ADDENDUM

ADDENDUM NO. 3

RE: New Bedford Marine Commerce Terminal
Phase 3 Bulkhead Replacement (Site 4)
Massachusetts Clean Energy Technology Center
Contract No. MACEC-FY26-02

PRECAST
PILE CAP
DETAIL 1 OF 7

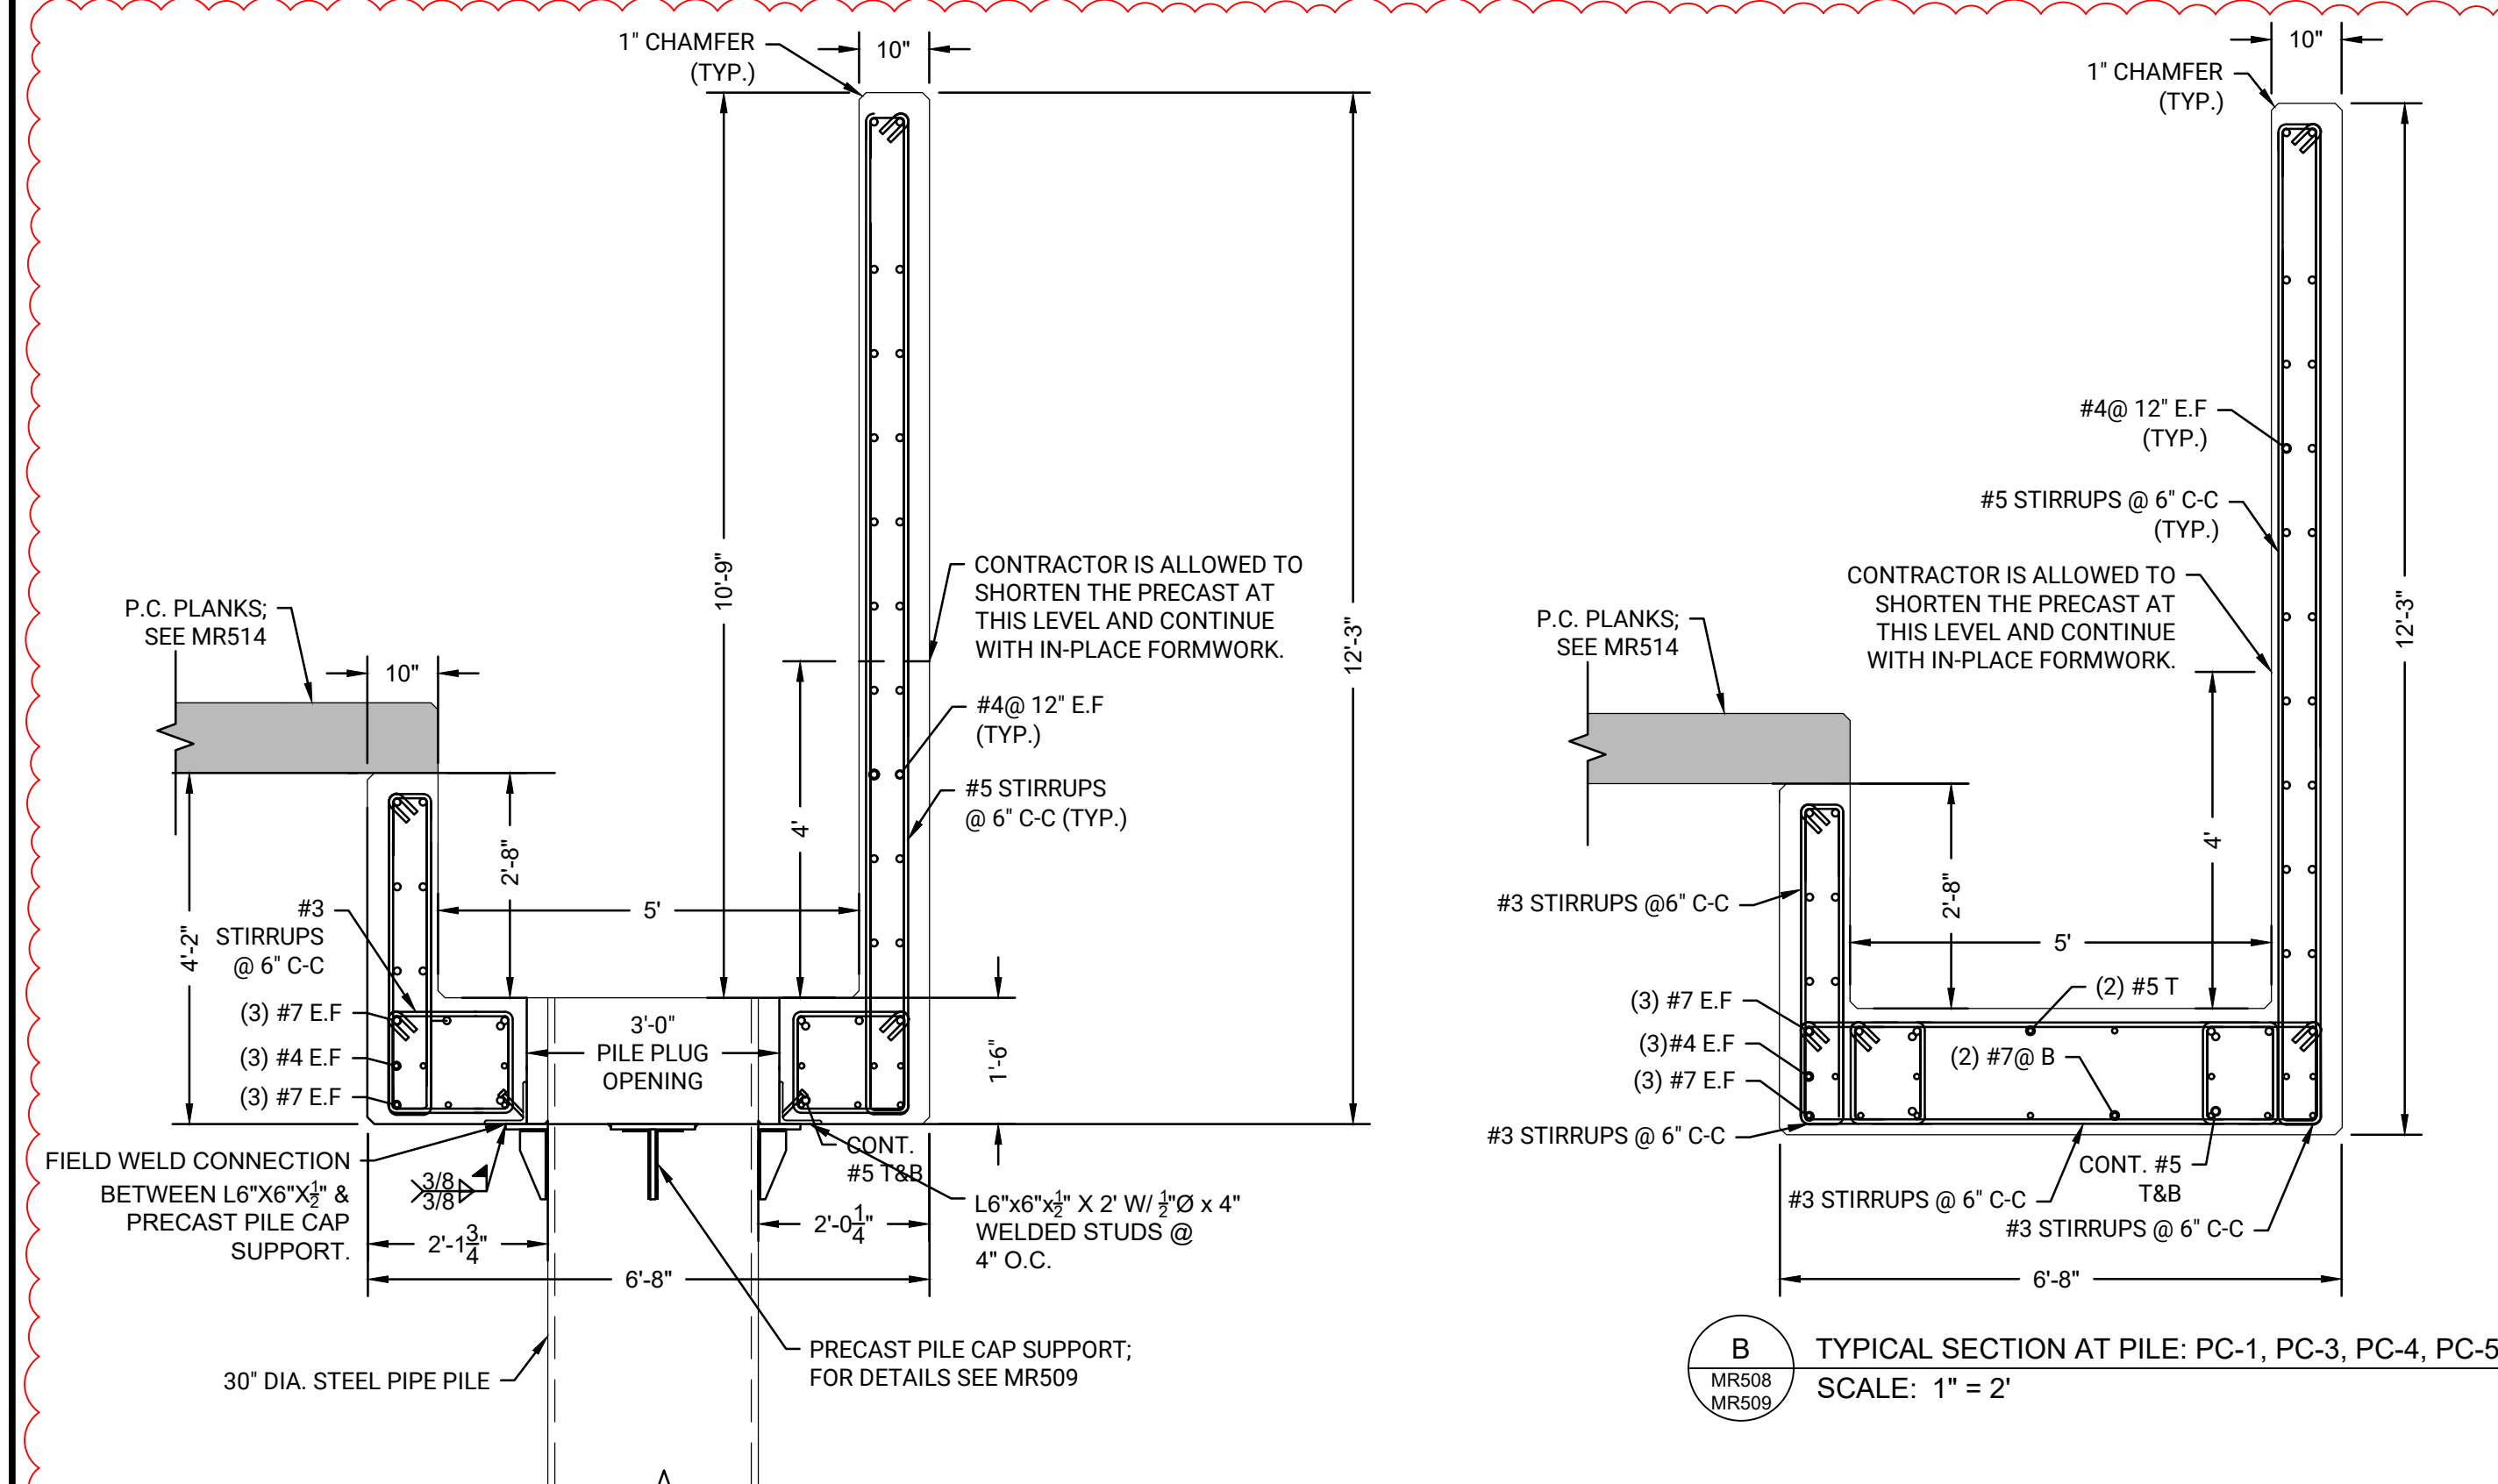
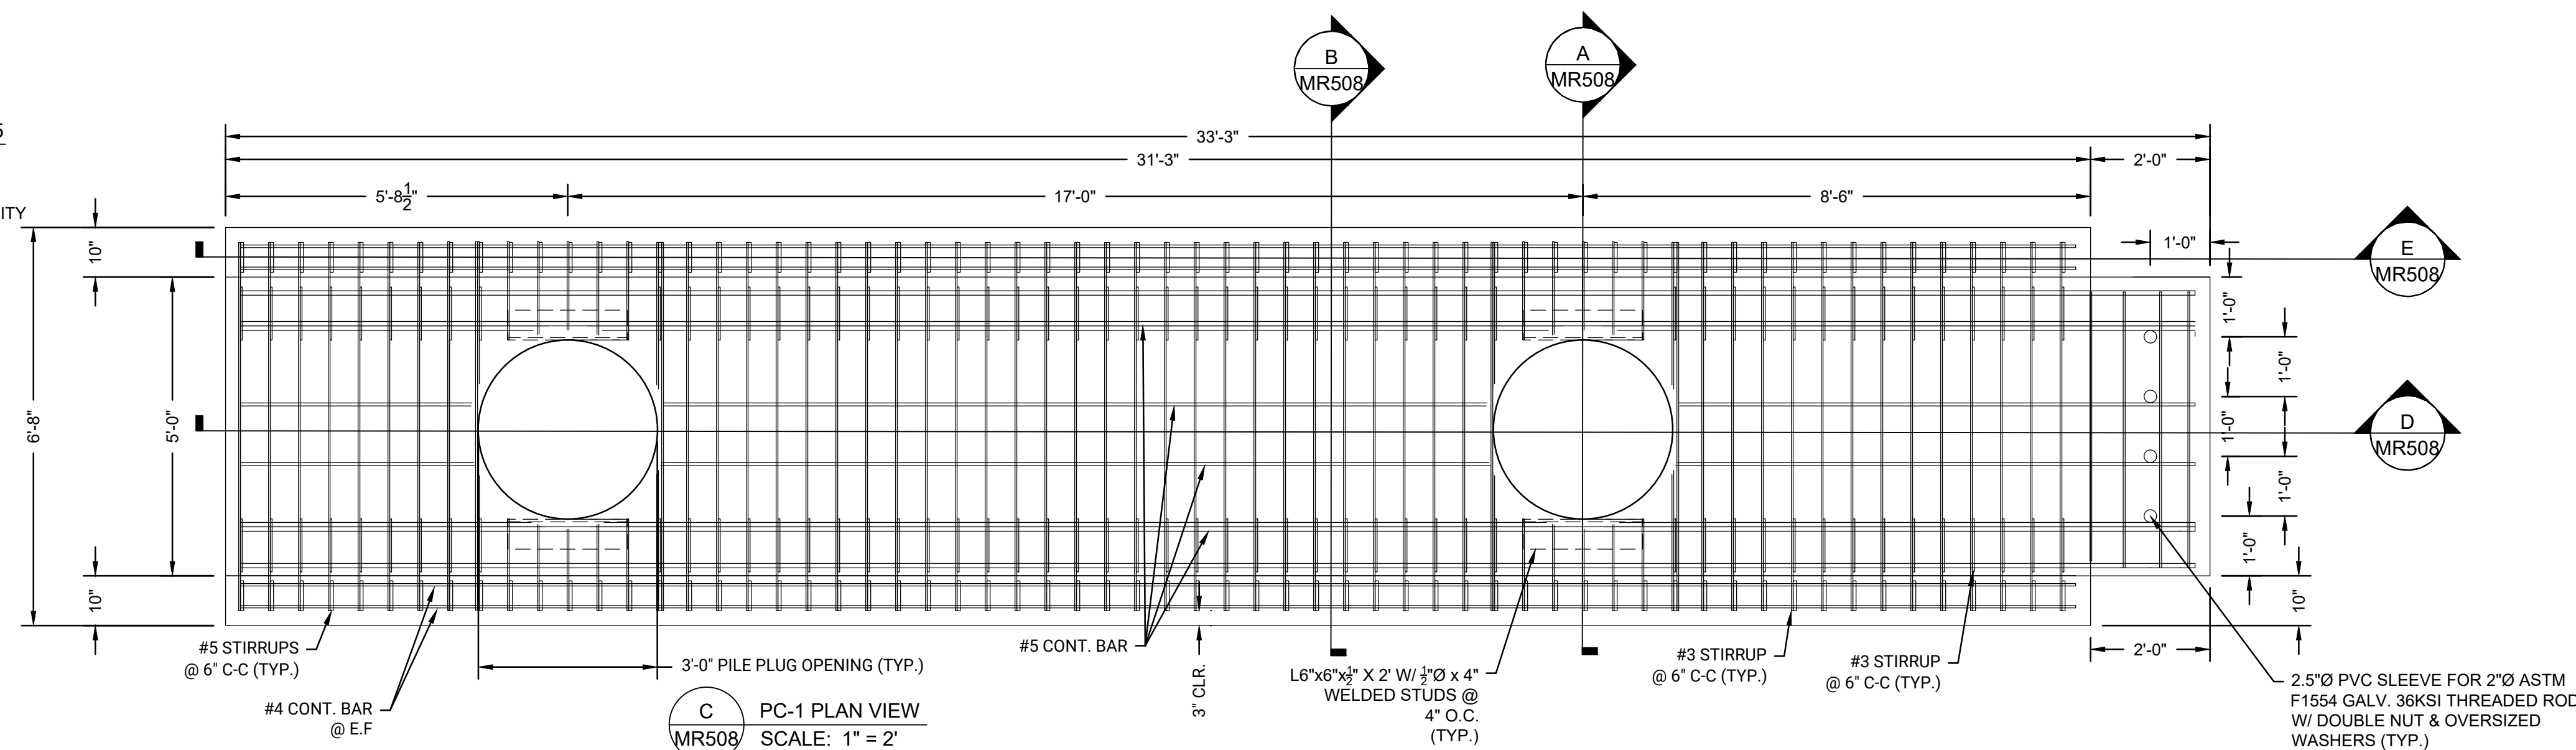
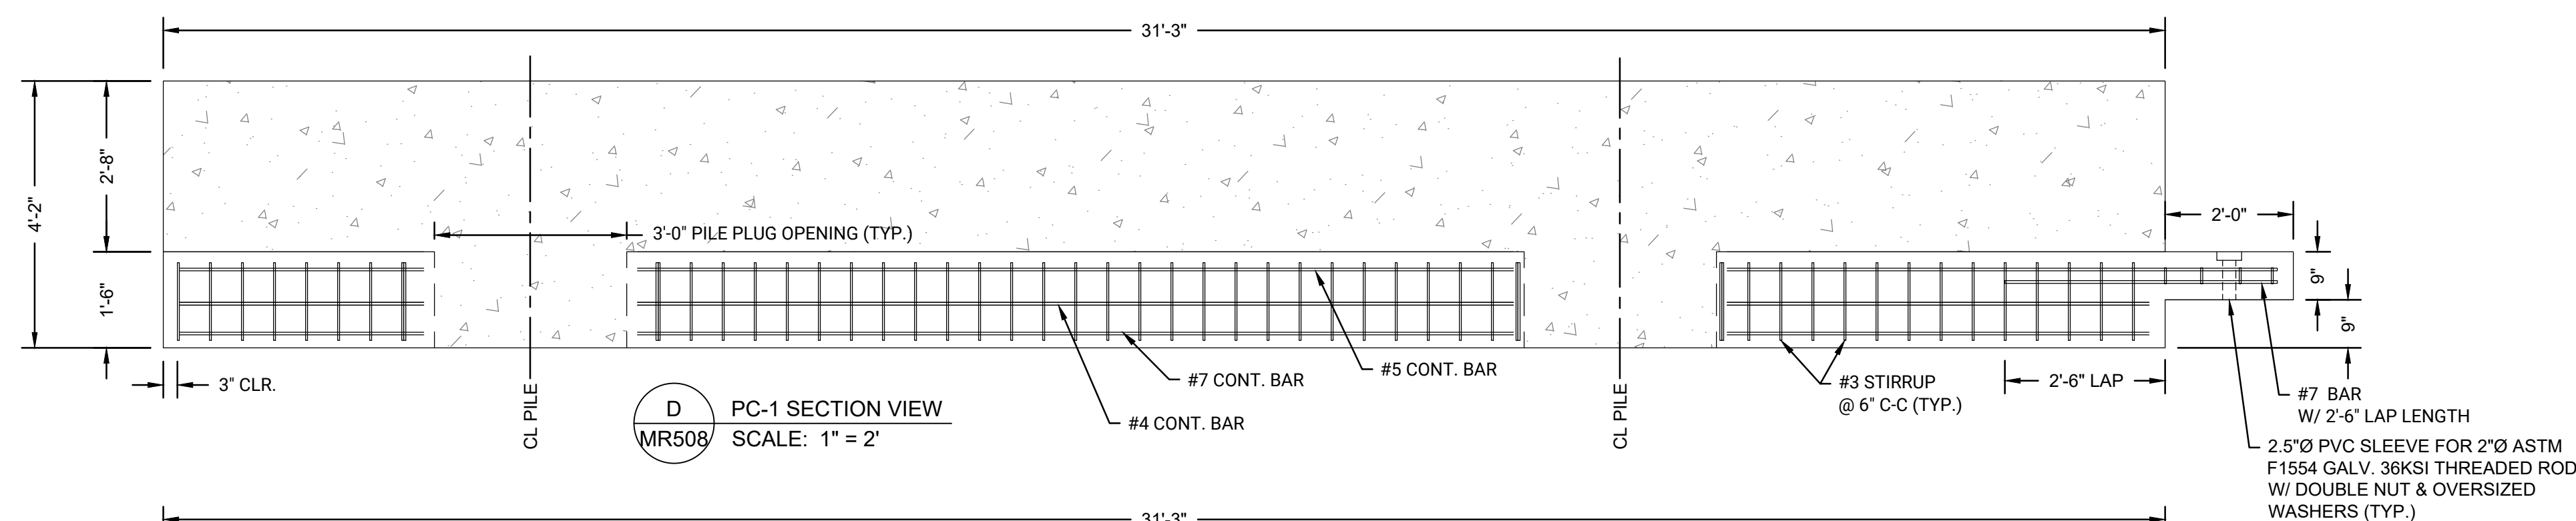
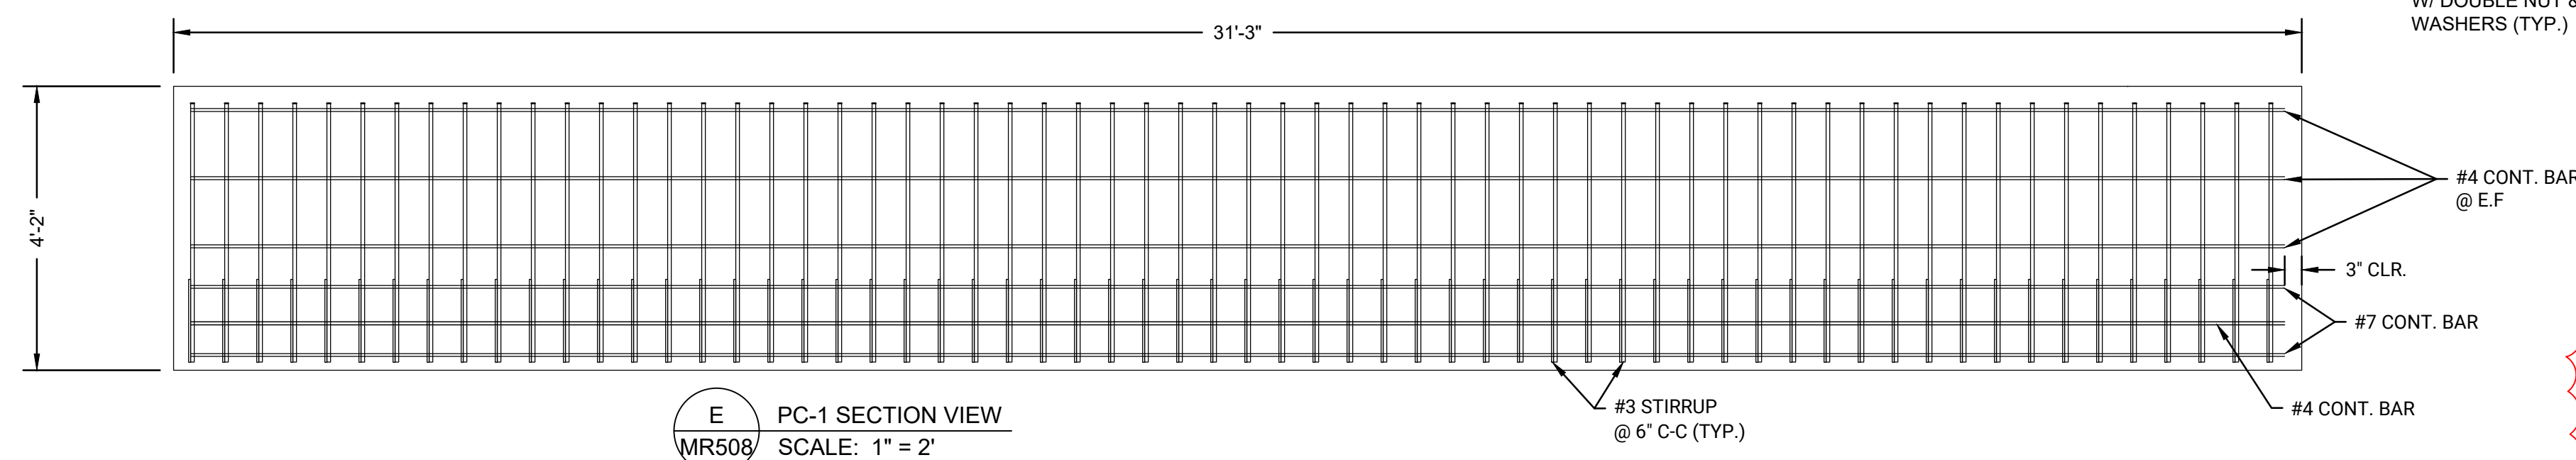
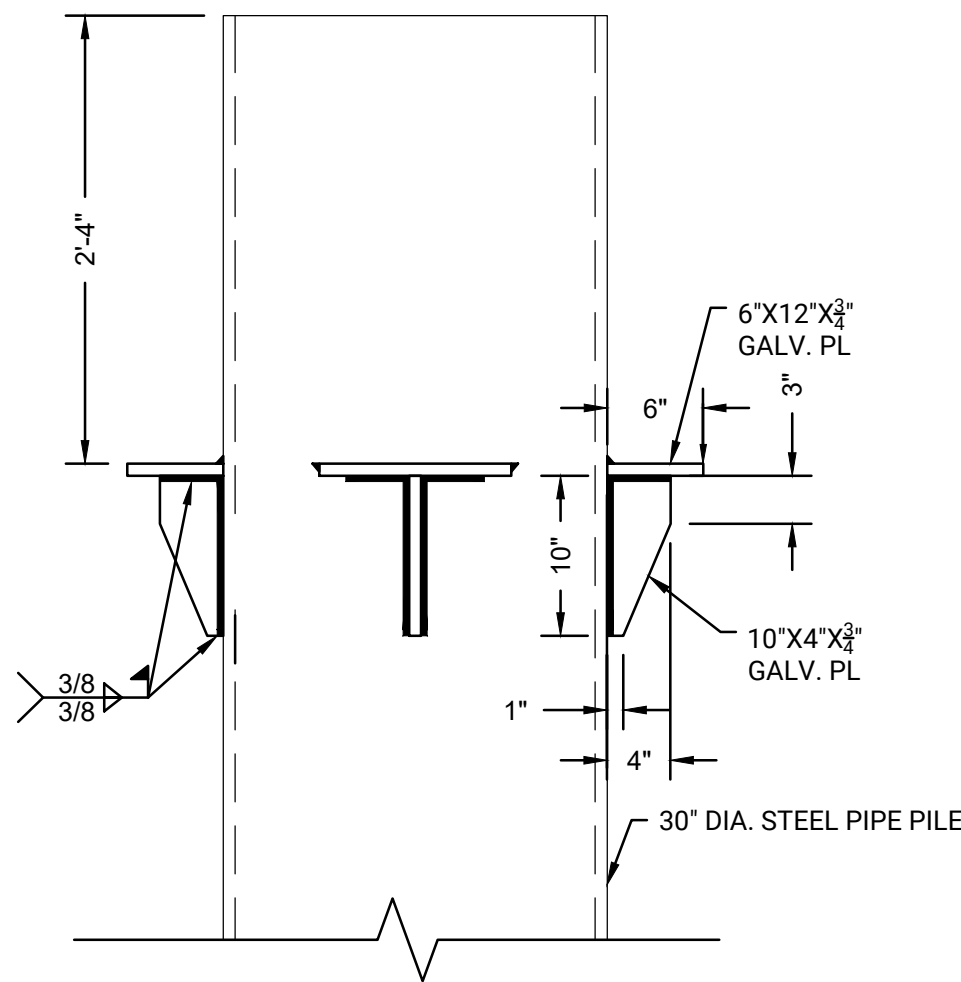
1. Drawings MR102 and MR508 through MR511 have been revised to reflect precast pile cap configuration addressing Question #2 (below). The revised Drawings are provided in **Attachment 1** to this Addendum No. 3.

1. Q: Will spiral weld pipe be acceptable?
A: YES, spiral weld pipe will be allowable steel pipe pile product.
2. Q: Are Pile Caps PC-1 to PC-8 connected to each other? If so, please provide a connections detail.
A: Please refer to the revised Drawings MR102 and MR508 through MR511, and the new Drawing MR511A. PC-1 through PC-6 have been resized and detailed to address precast pile cap connections.
3. Q: Please refer to the snapshot below from MR017. The red hatched area represents a gap between the proposed platform slab and existing Cofferdam cell which will be exposed to the open water below. Please provide a closure detail between the proposed platform slab and Cofferdam Cell to close this space.
